**REQUEST FOR TENDER
ORANGUTAN OUTDOOR EXHIBIT CONSTRUCTION
RFT#: TZC T 10-2020-02
ADDENDUM # 2**

Date Issued: 2020 March 13
Project Name: **Toronto Zoo Orangutan Outdoor Exhibits**
To: Ben Knoop
Toronto Zoo
361A Old Finch Avenue
Toronto, ON M1B 5K7
Project Number: 18-1-086
RFT Reference No.: TZC-T-10-2020-02 (issued 2020-02-18)

ADD #A002

SCALE: AS NOTED
FEBRUARY 13, 2020 **AR-140**

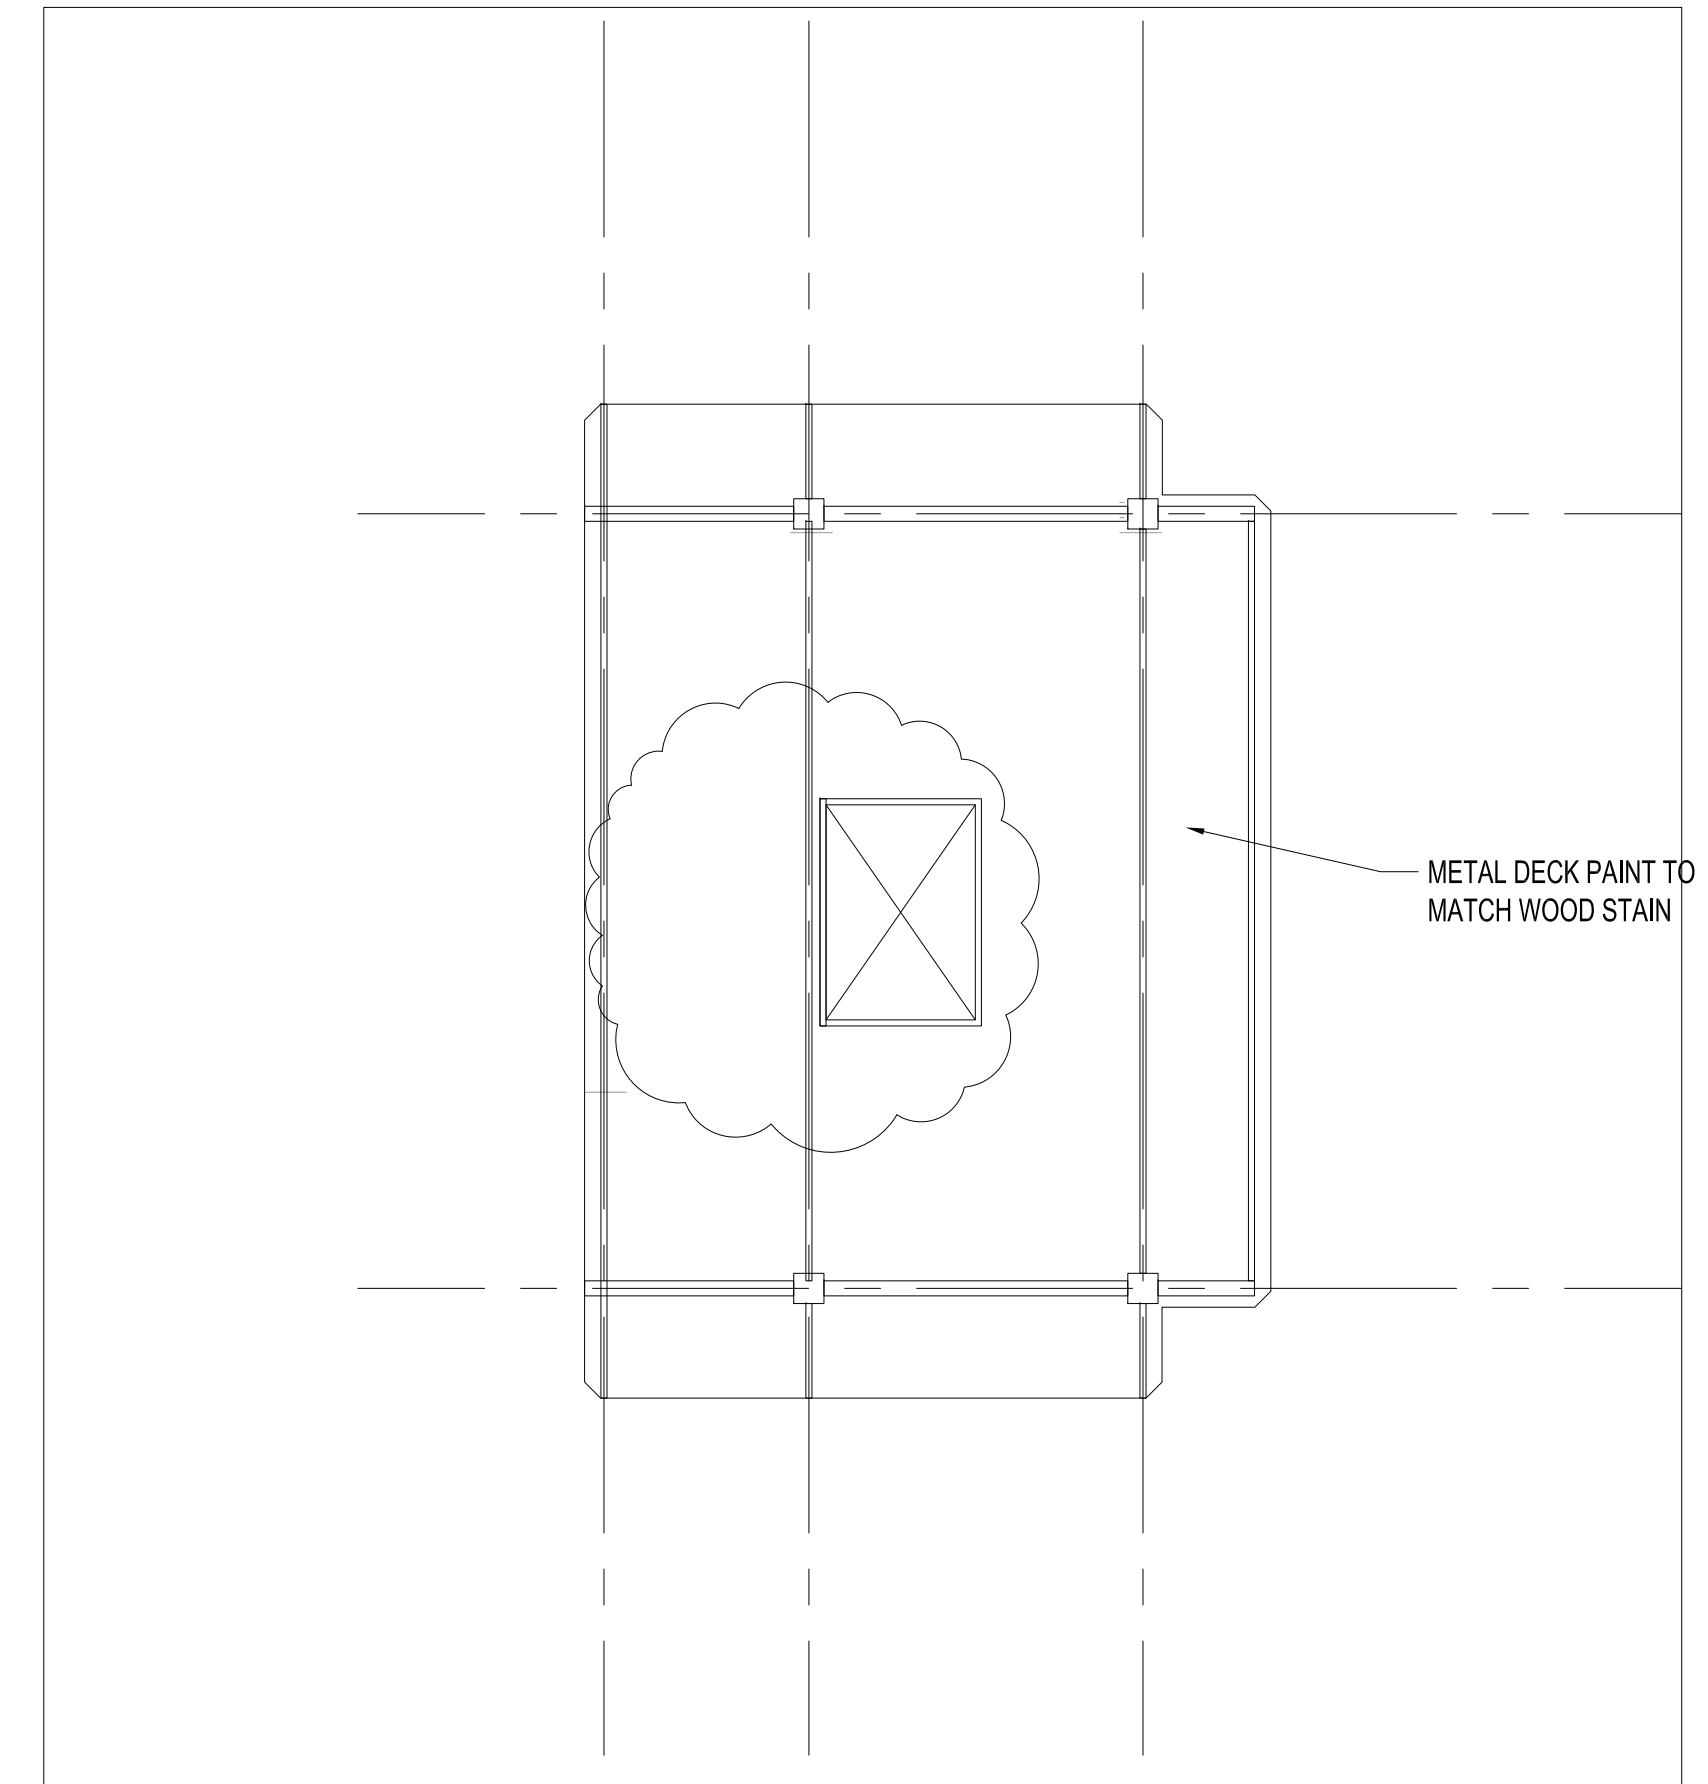
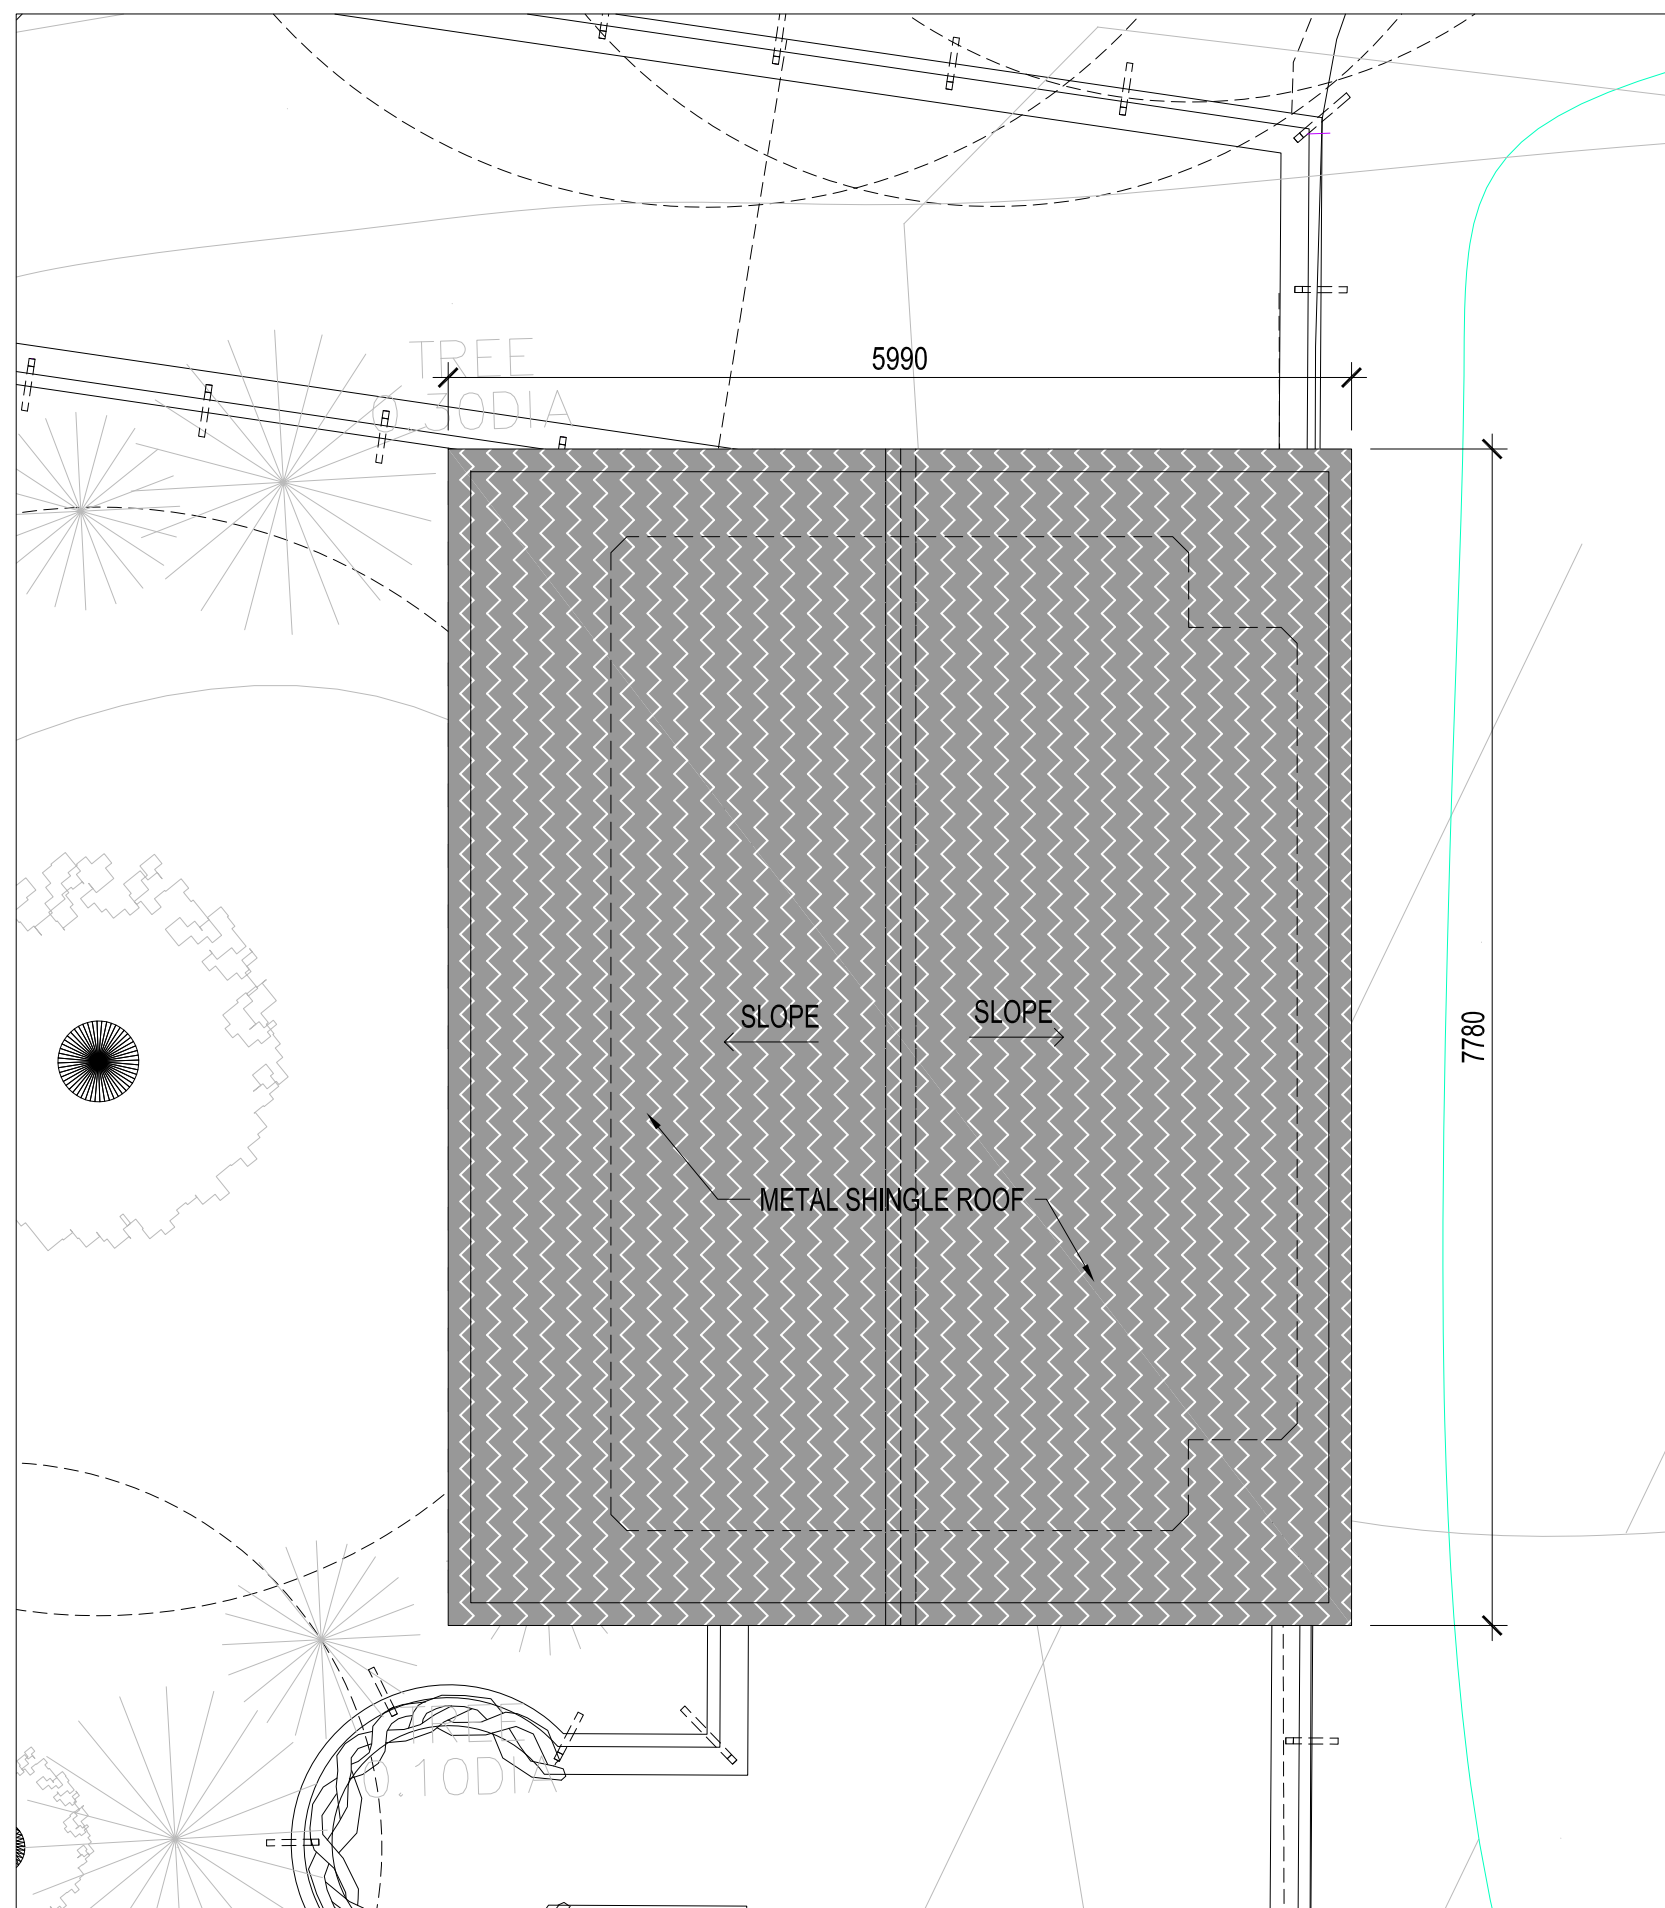
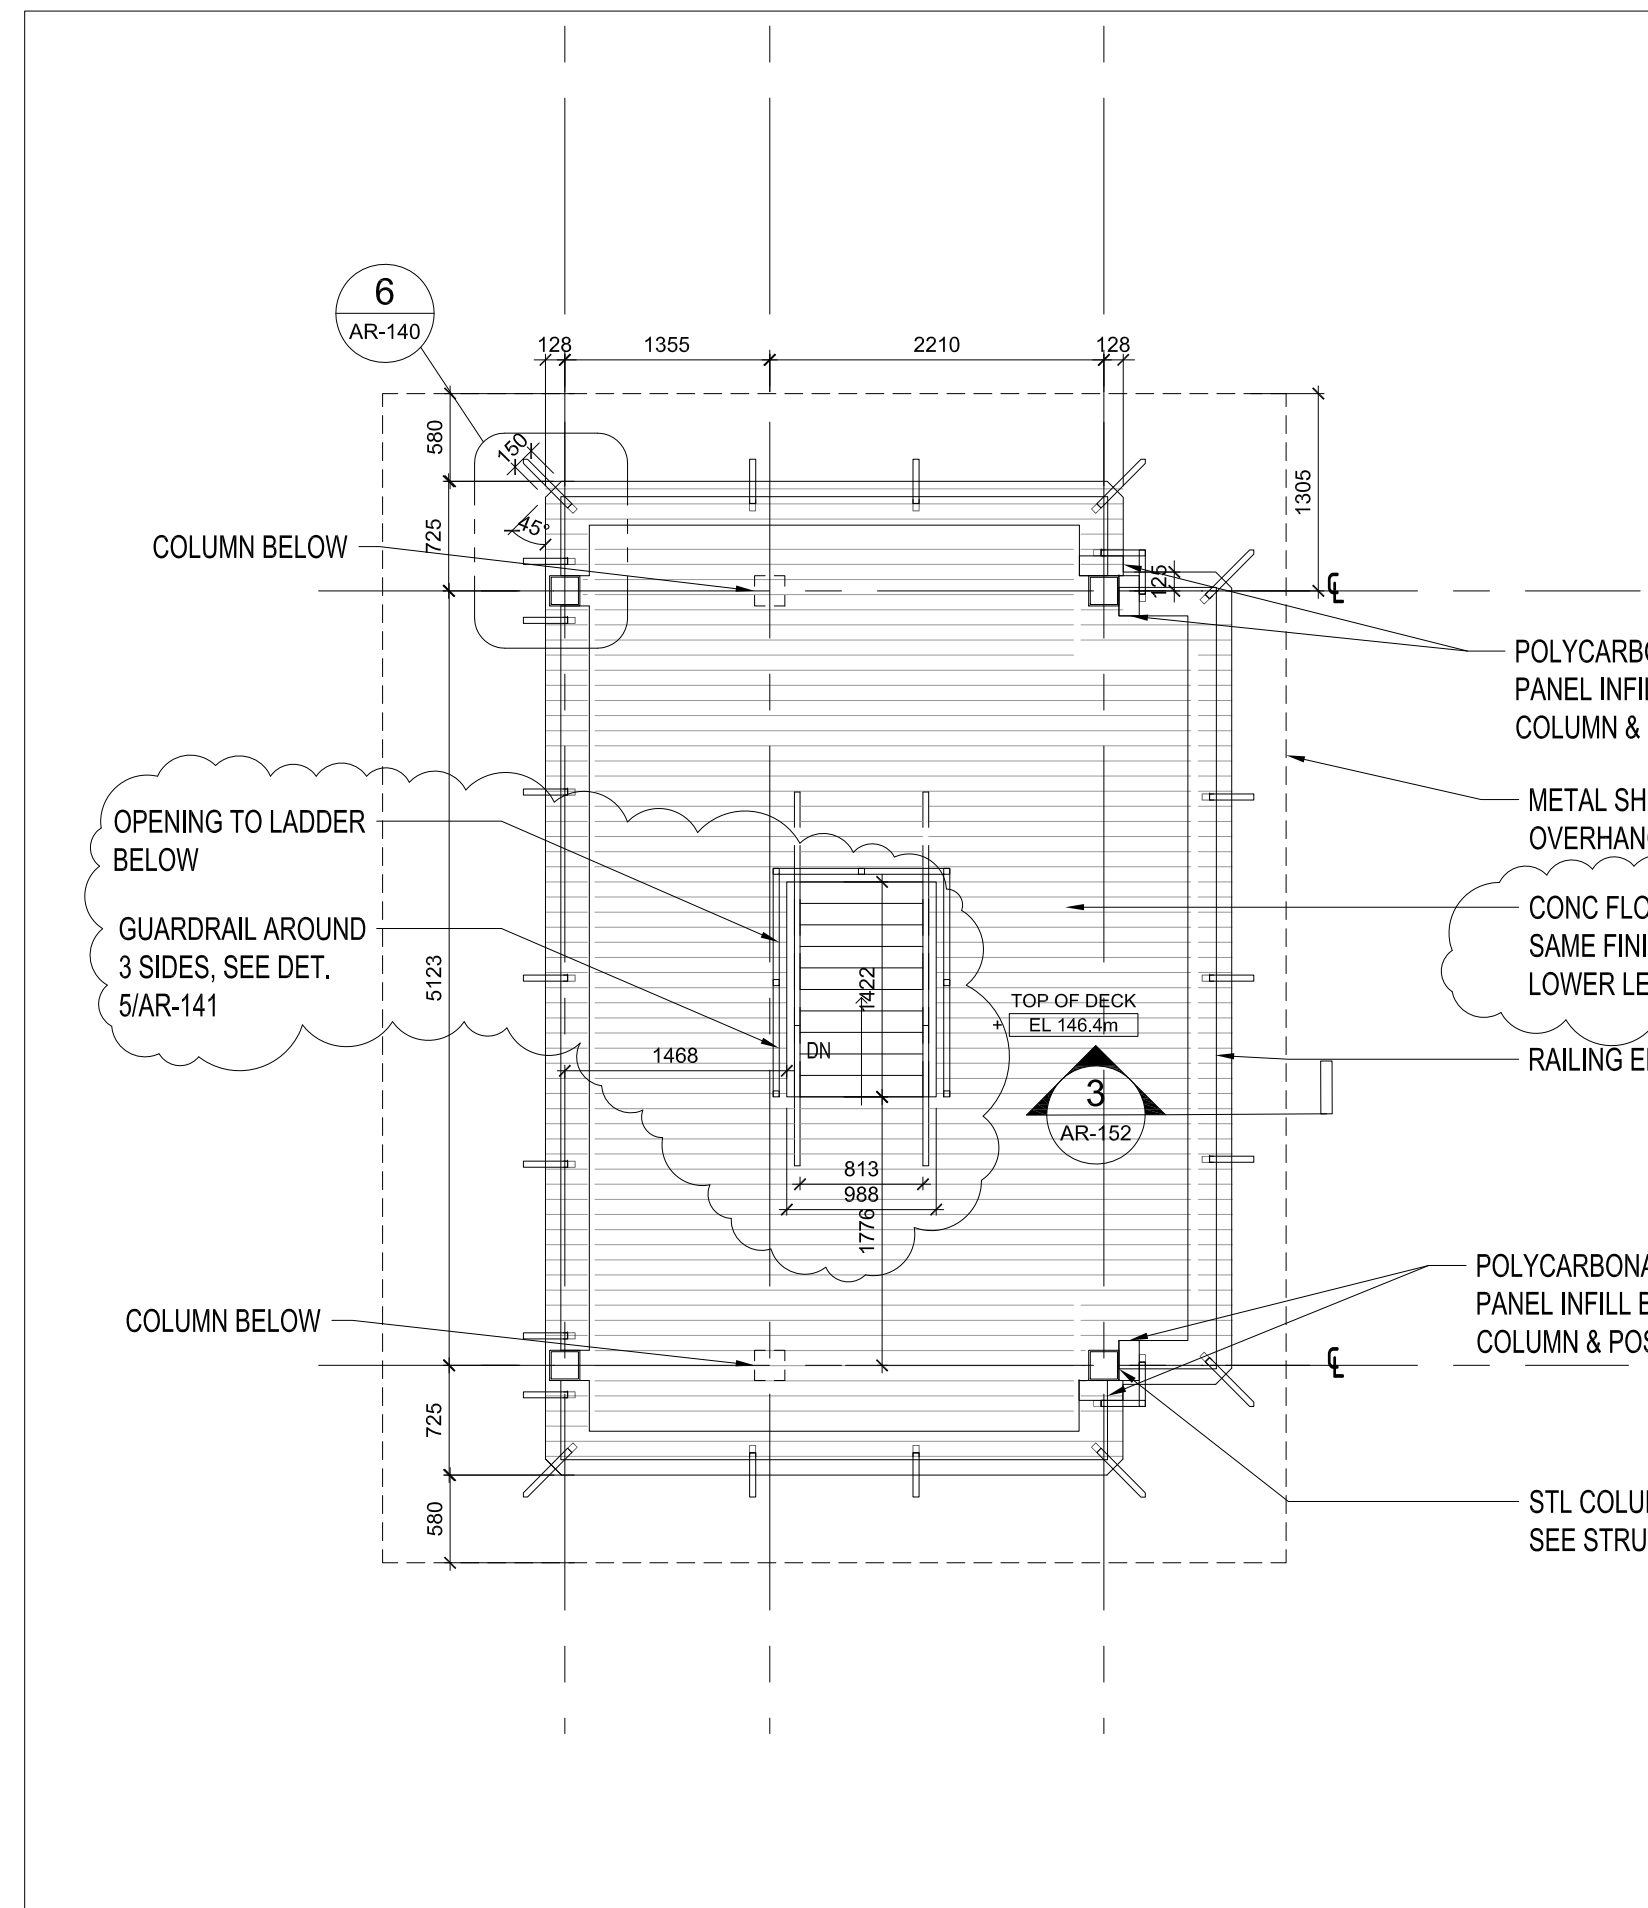
(A)		7 Drawing 3/AR-140 & 2, 3, 4/AR-141 – The upper floor deck is concrete on metal deck as per structural plan 3/S-210 & section 2, 3/S-810. Not cedar floor. Please clarify.	Zediler/RJC	Arch details to be revised to match structural's dwg (conc on metal deck).
